Certificate of Appropriateness

830 N. 24th Street, West Avenues West Historic District

Repair the current porch with like materials. Wood posts, railings, decoration over the porch, risers and skirting will be repaired or replaced in-kind with wood. Repair K-style gutter above the second floor flat roof, with replacement in half-round acceptable if desired.

Existing porch conditions

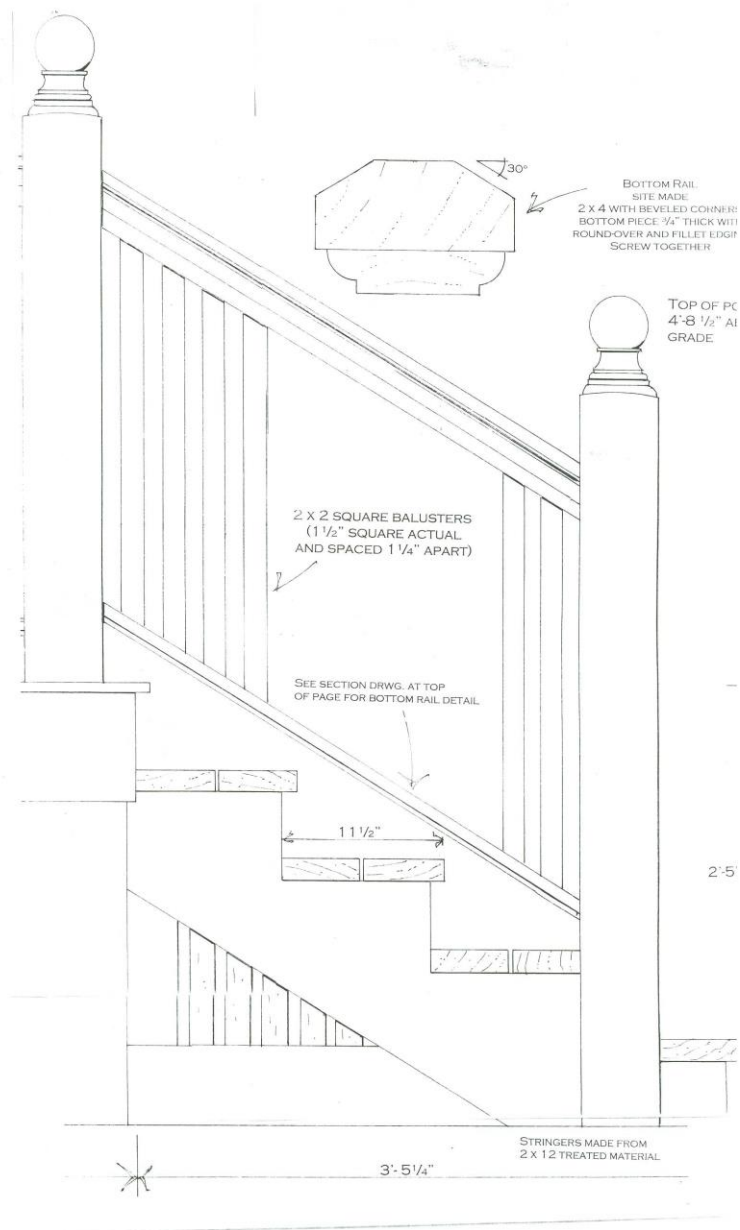
New porch rails will be molded and baluster spacing to match the design above
